IN-FLIGHT ICING ENCOUNTER AND LOSS OF CONTROL
SIMMONS AIRLINES, d.b.a. AMERICAN EAGLE FLIGHT 4184
AVIONS de TRANSPORT REGIONAL (ATR)
MODEL 72-212, N401AM
ROSELAWN, INDIANA
OCTOBER 31, 1994

VOLUME II: RESPONSE OF BUREAU ENQUETES-ACCIDENTS
TO SAFETY BOARD'S DRAFT REPORT

COMMENTS OF THE BUREAU ENQUETES ACCIDENTS (FRANCE)

DRAFT FINAL REPORT ON THE ACCIDENT

FIGURE 2 : FLIGHT 4184 CVR TIME HISTORY

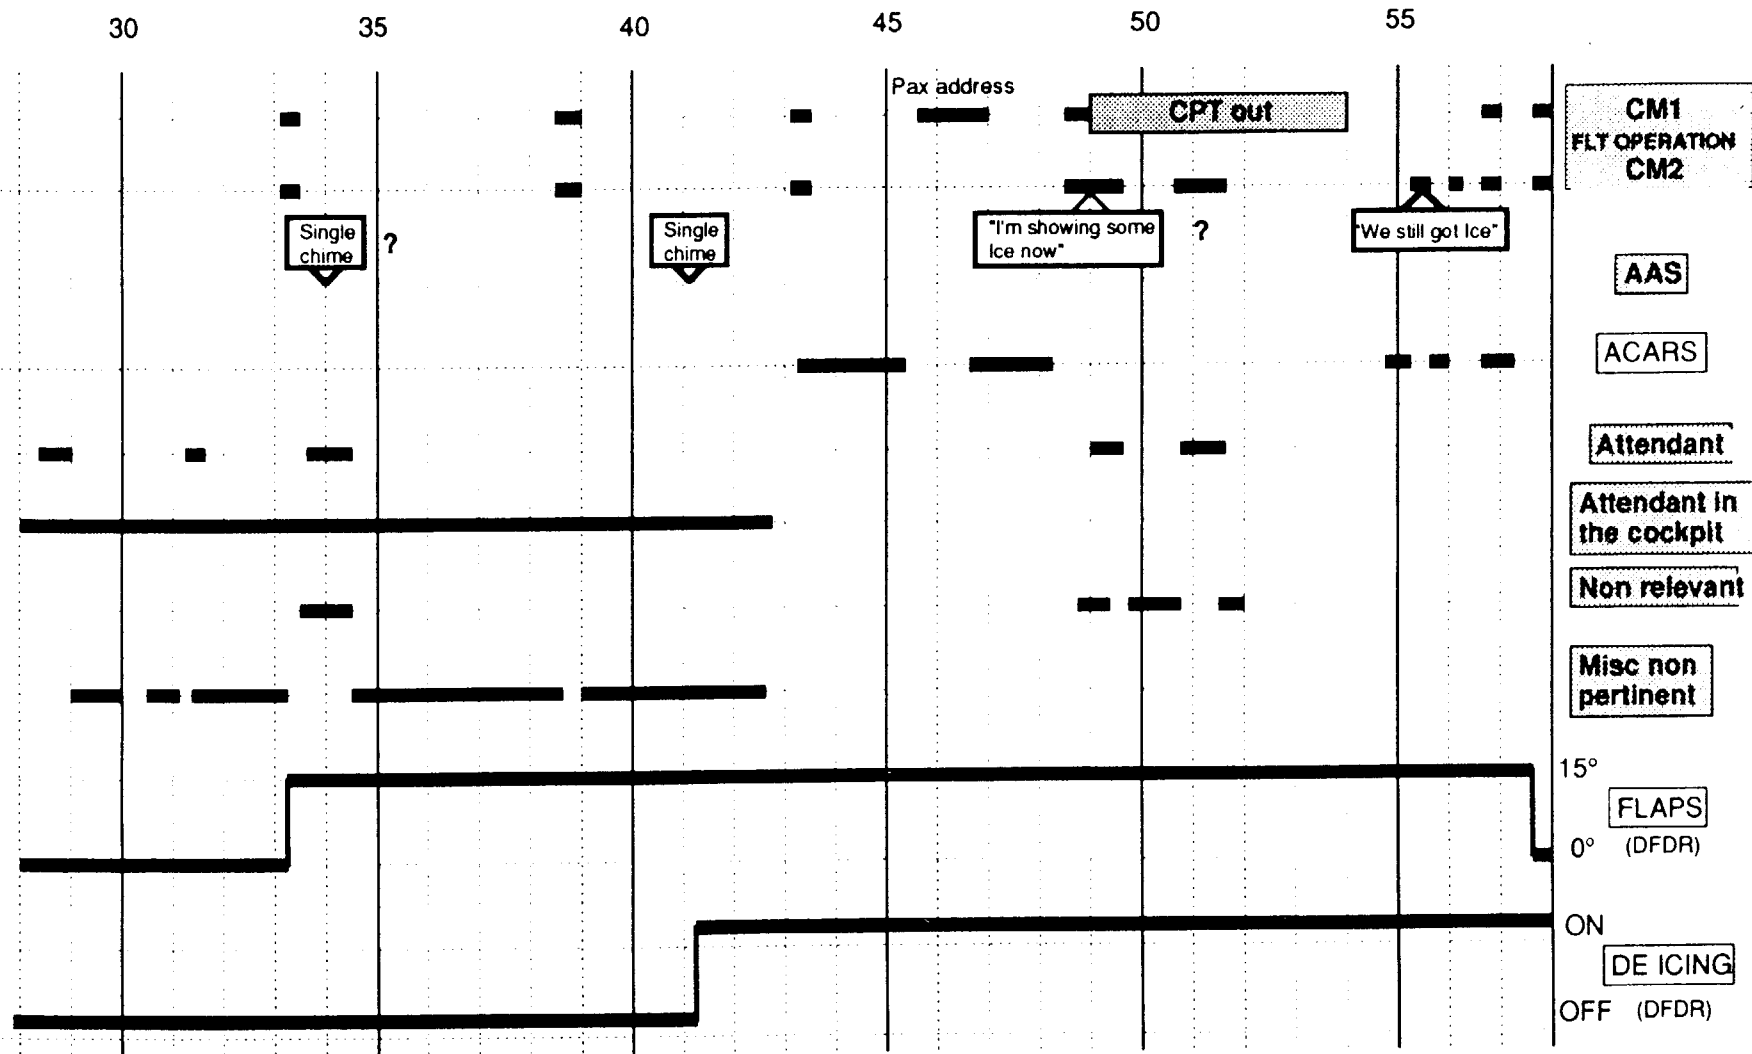
Flight 4184 CVR transcript by NTSB was highly unedited

FIGURE 14 : FLIGHT 4184 CVR TIME ANALYSIS

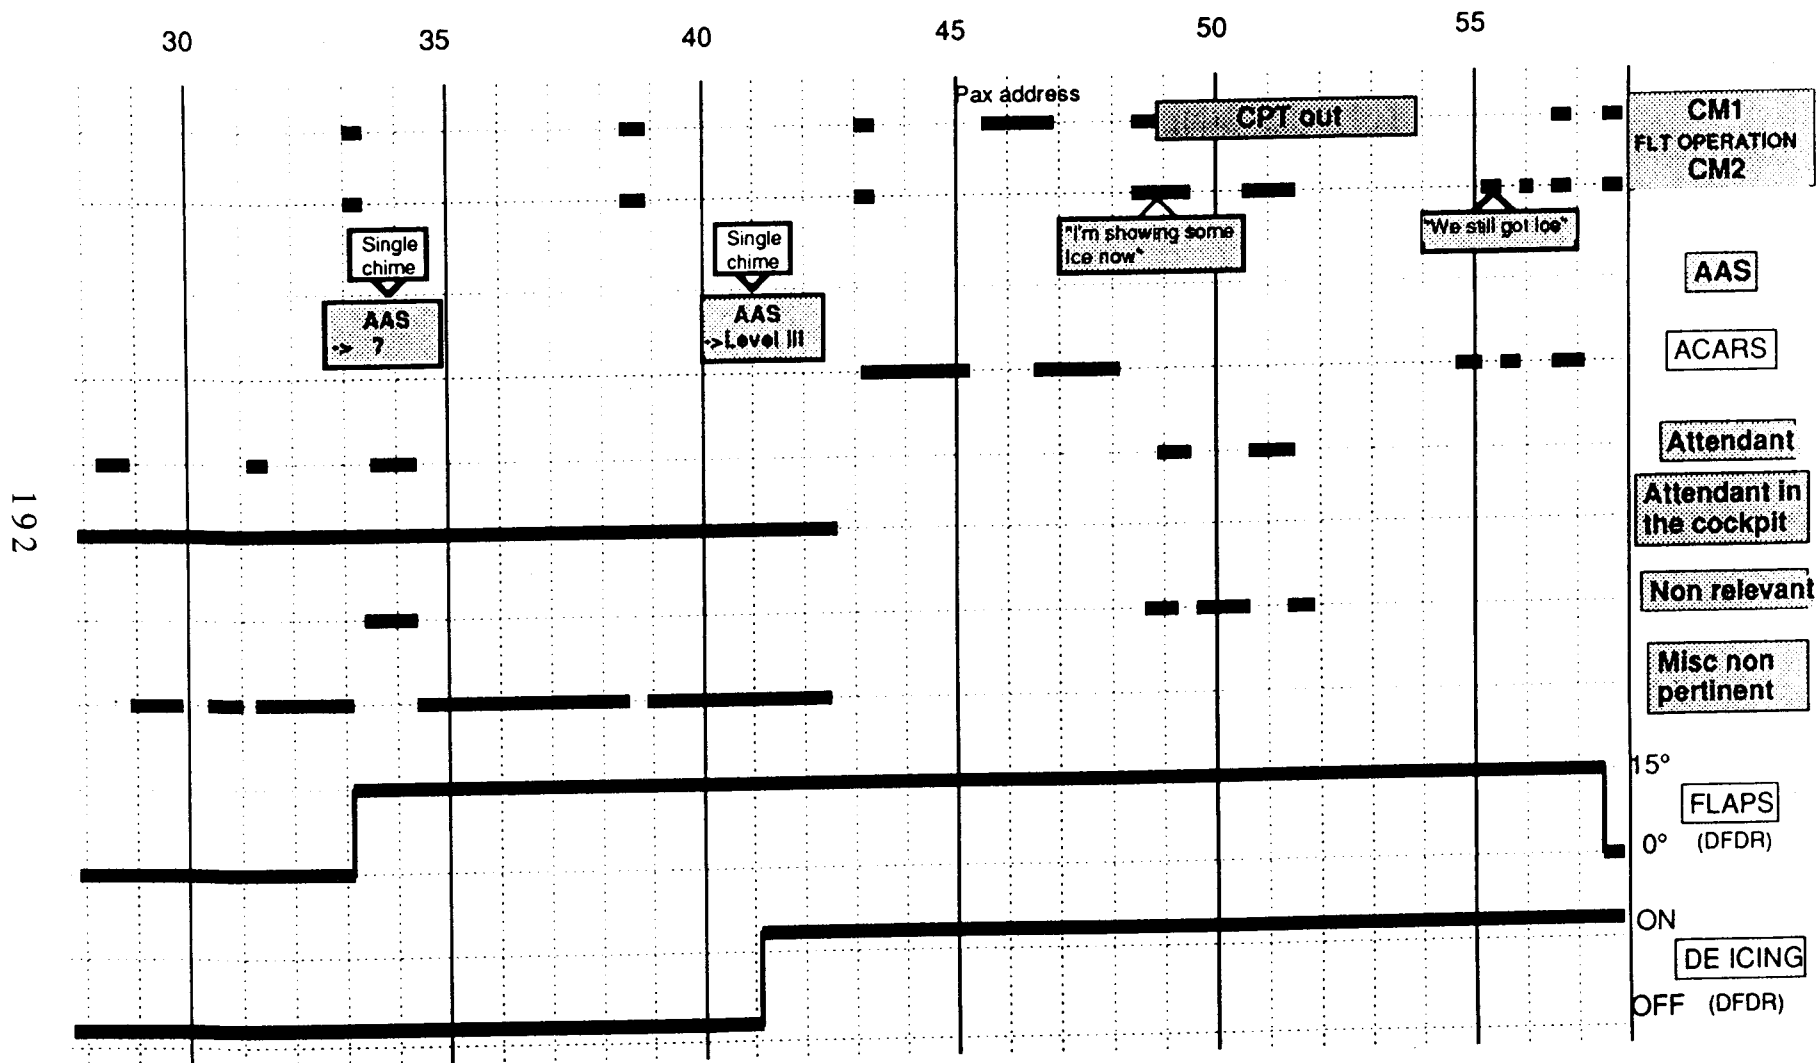
More than 15 mn of Non Relevant & Non Pertinent conversations

FIGURE 16 : PITCH CONTROL INPUTS / ACTIVITY AFTER ROLL UPSET

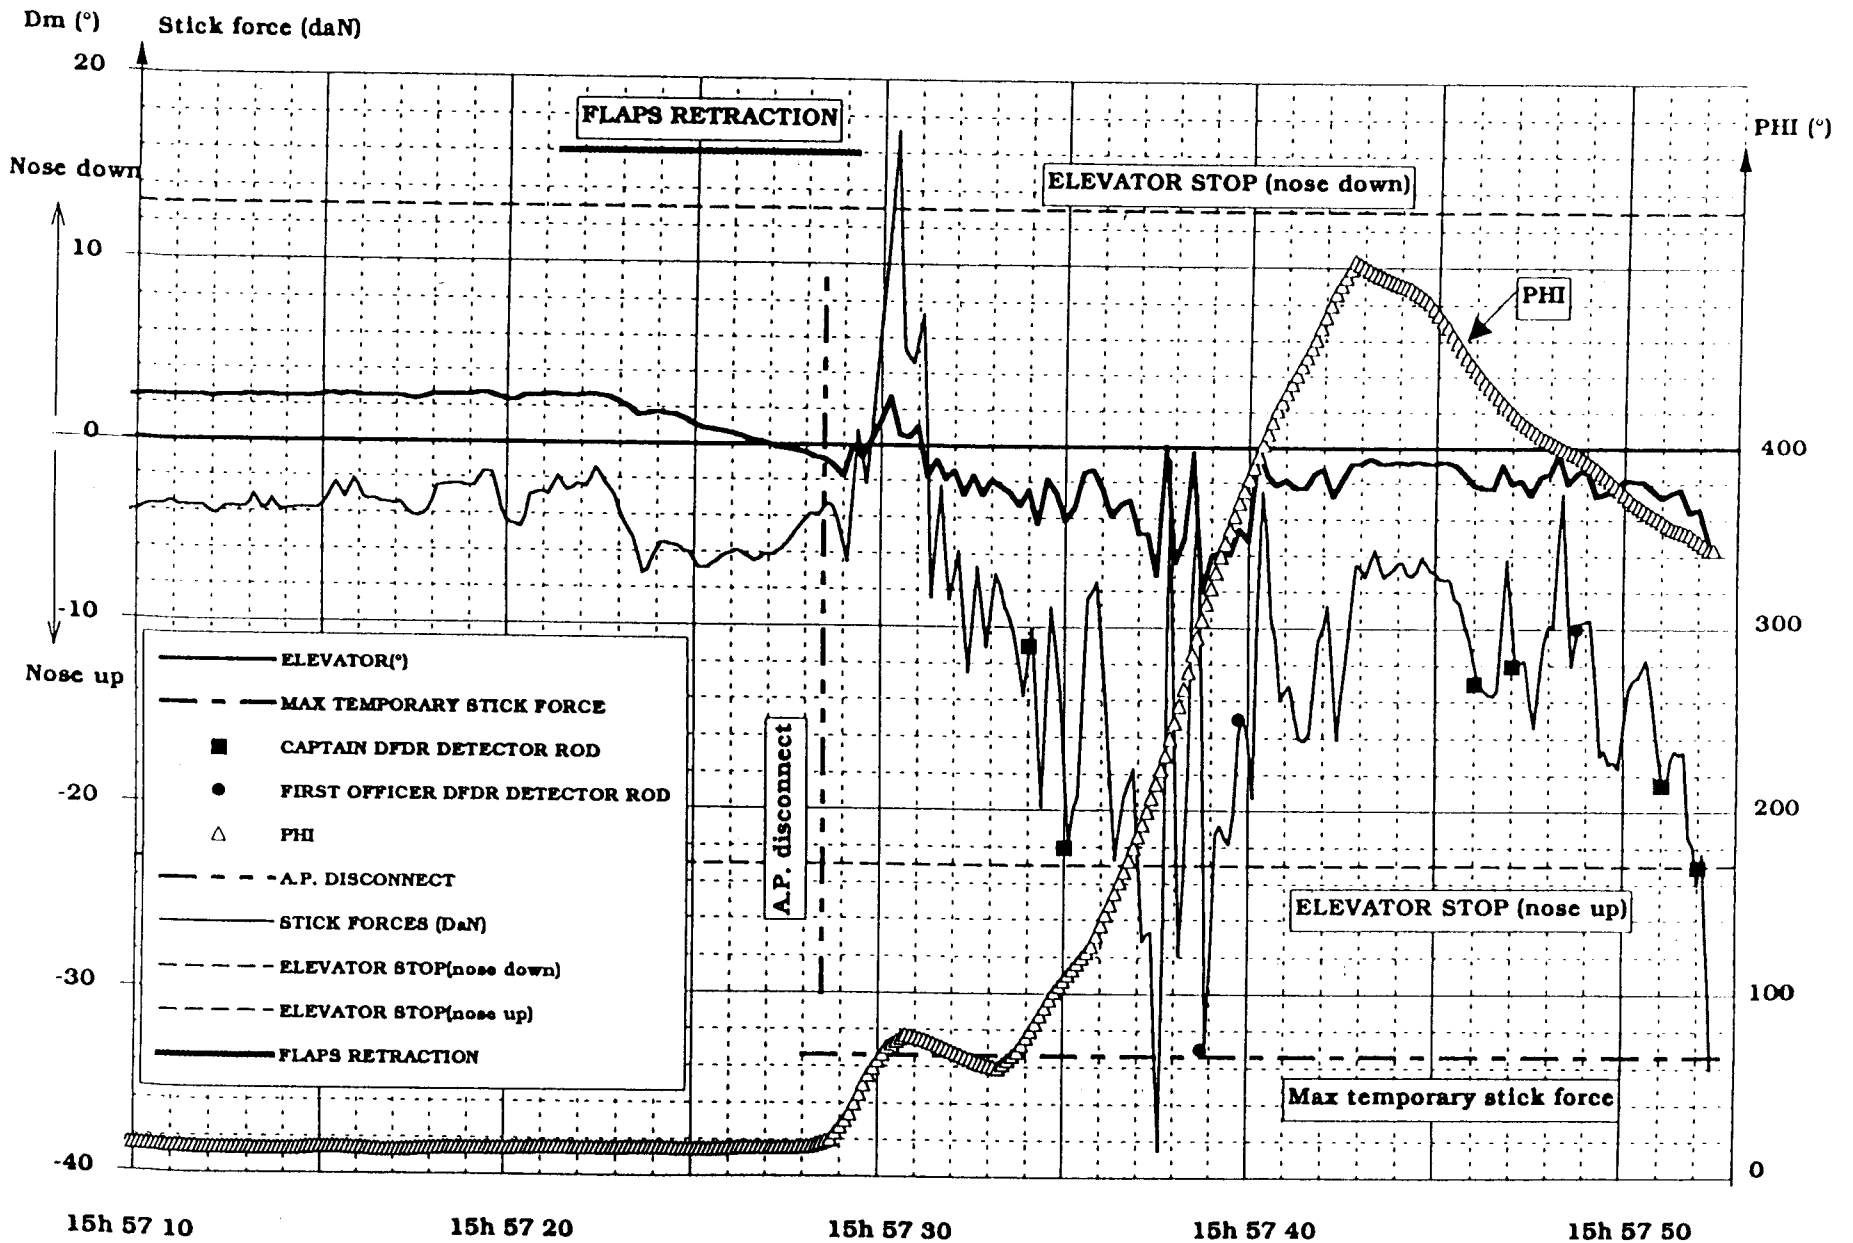
A limited control activity mainly during inverted flight

FIGURE 19 : RECOVERY CAPABILITY THROUGH CONSTANT ROLL INPUT

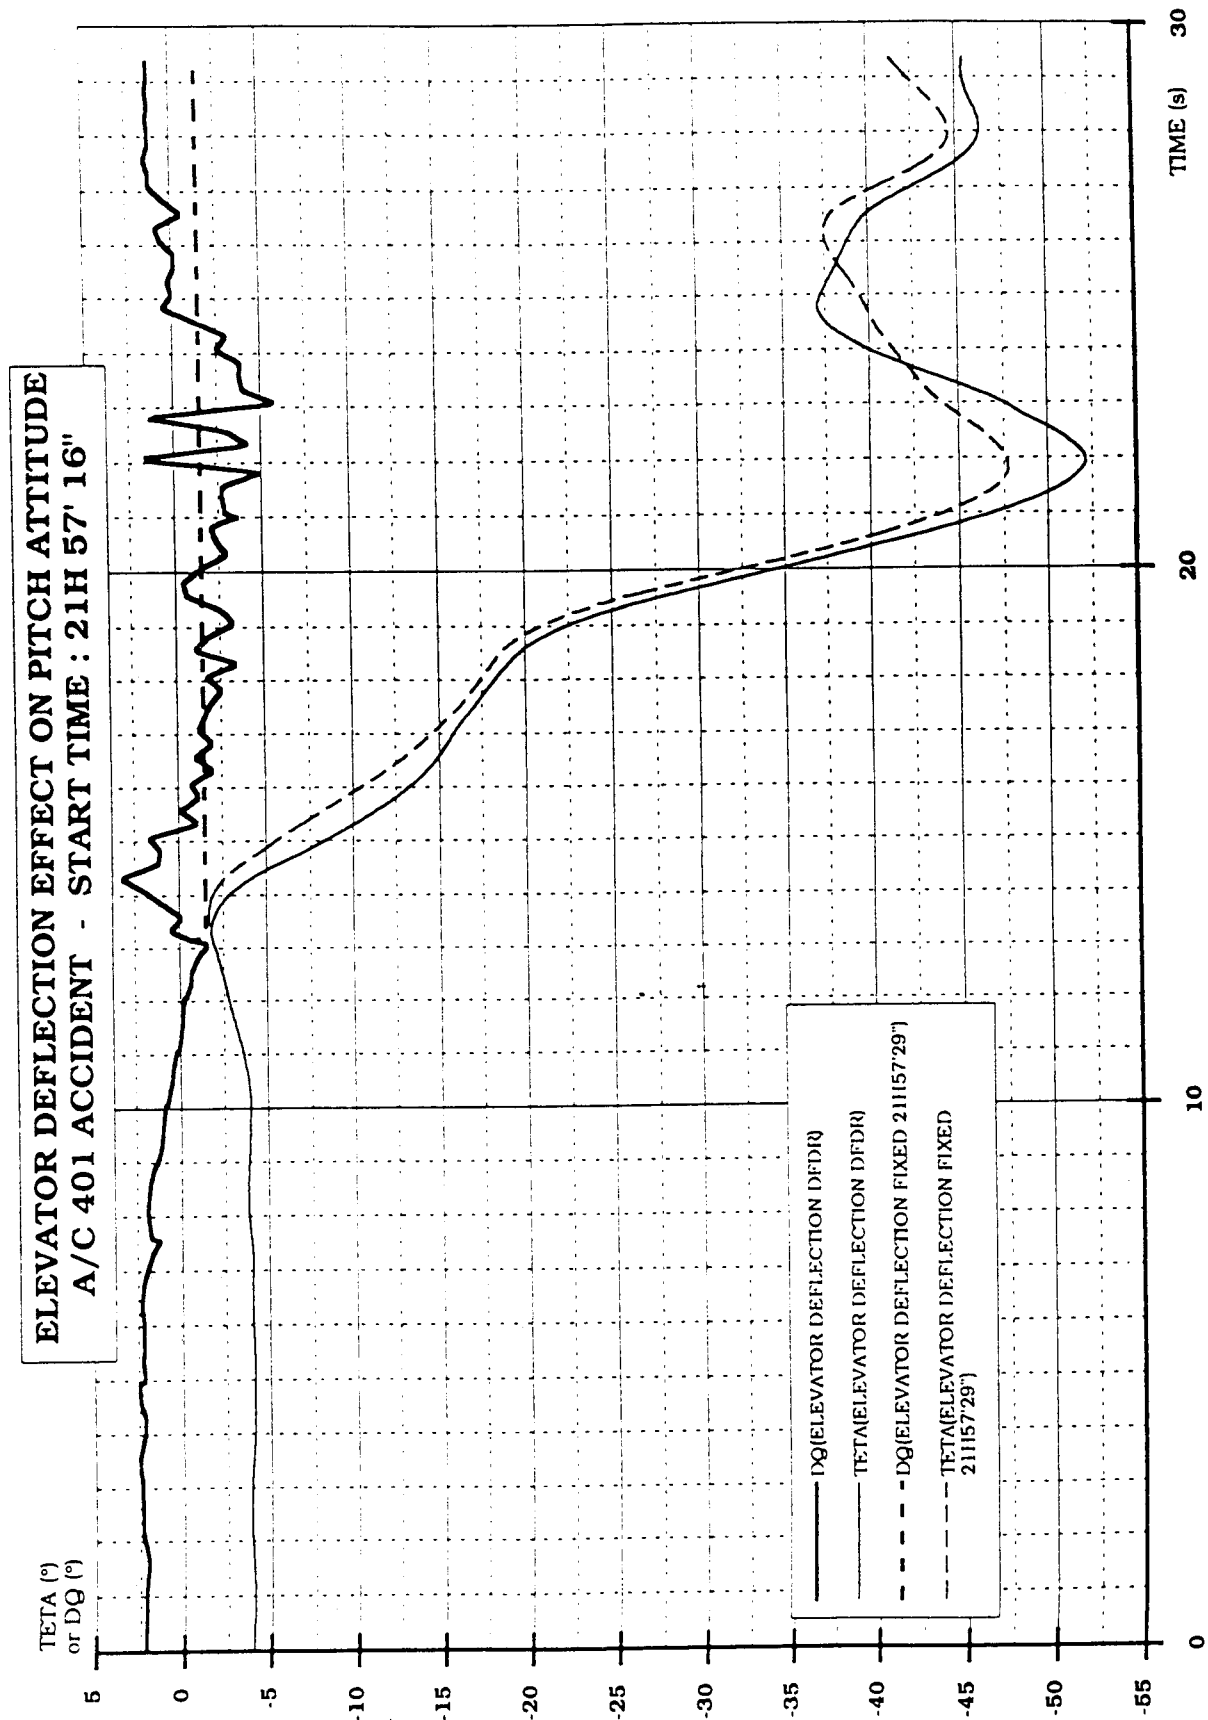
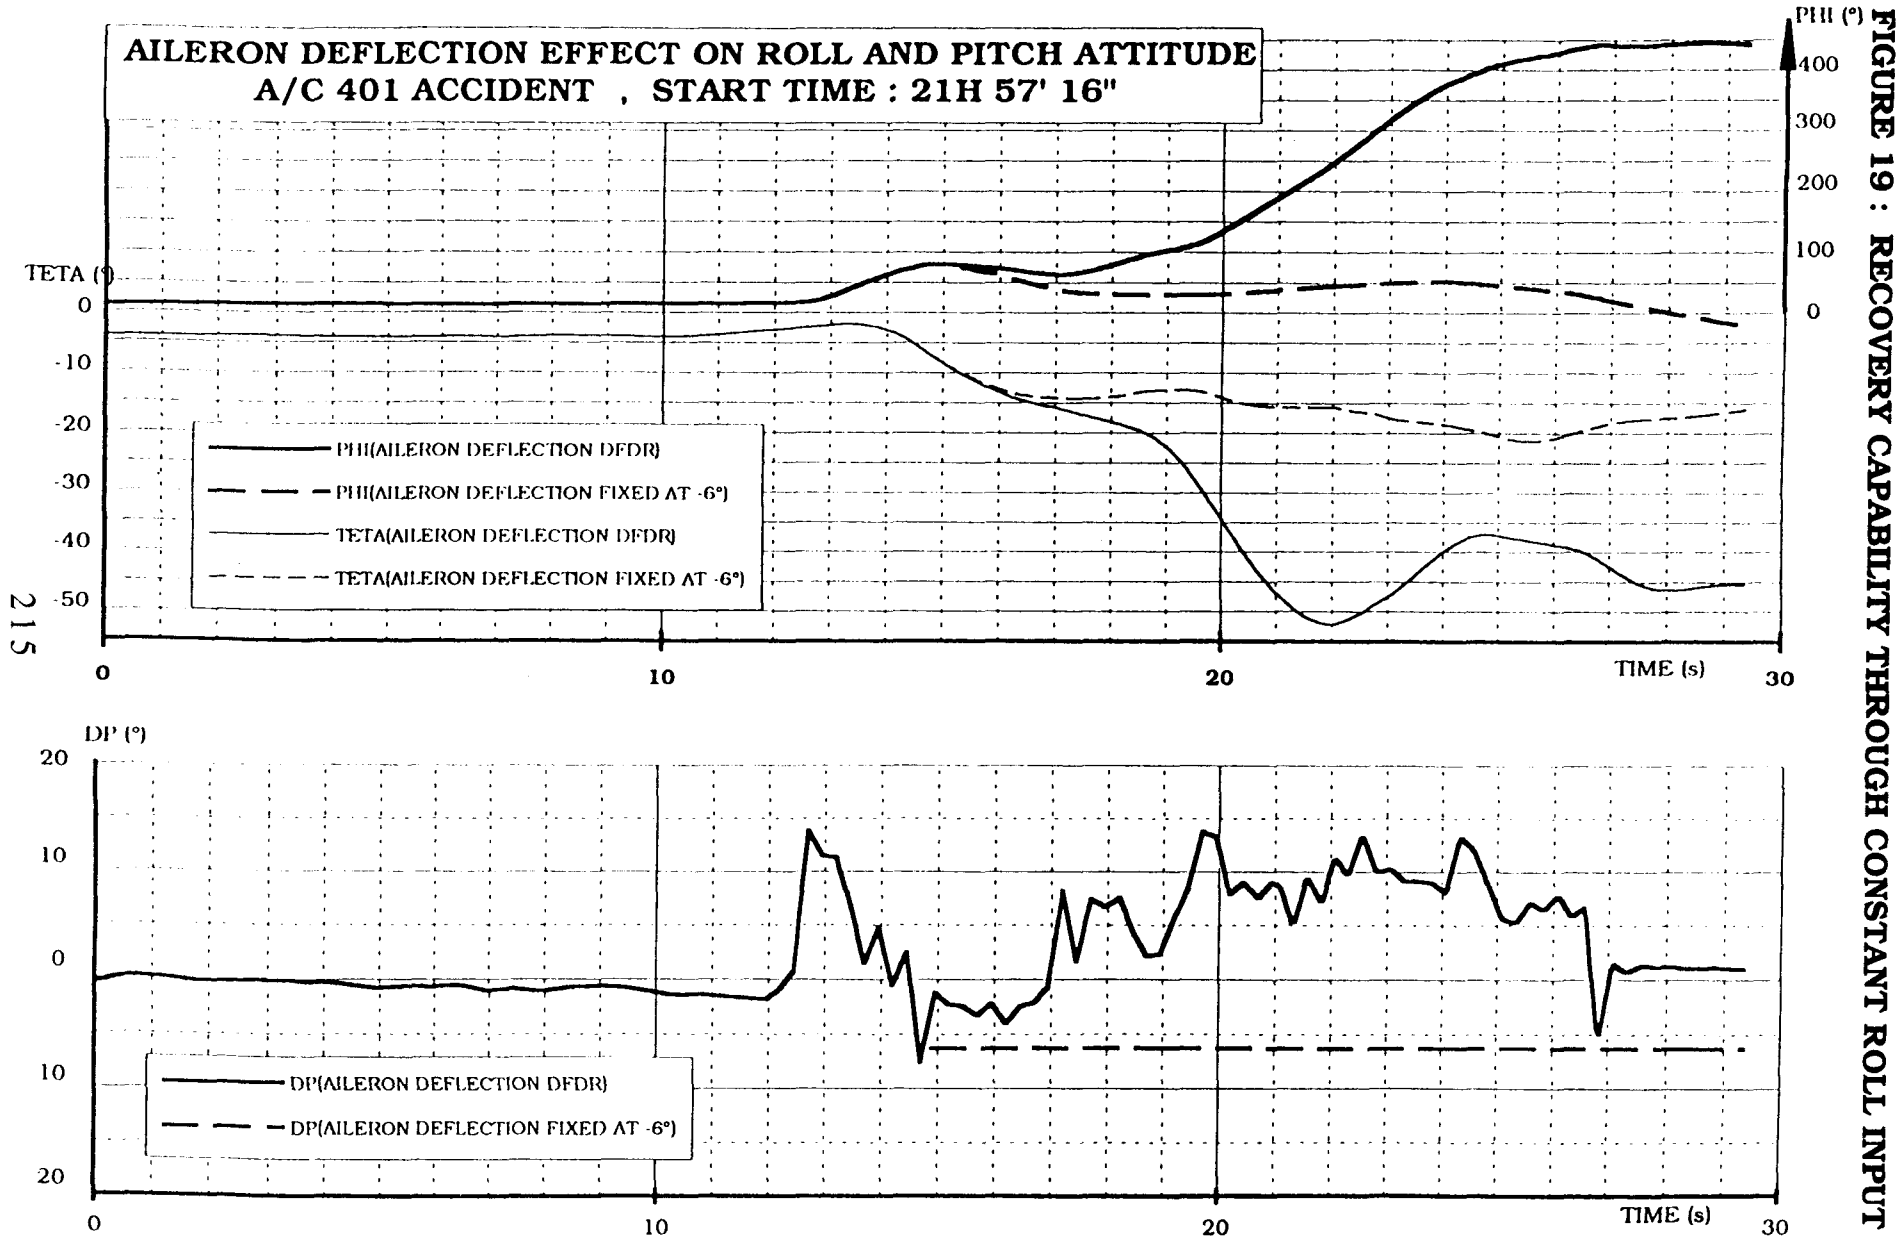
A constant 6° roll input after 3 sec would allow for recovery
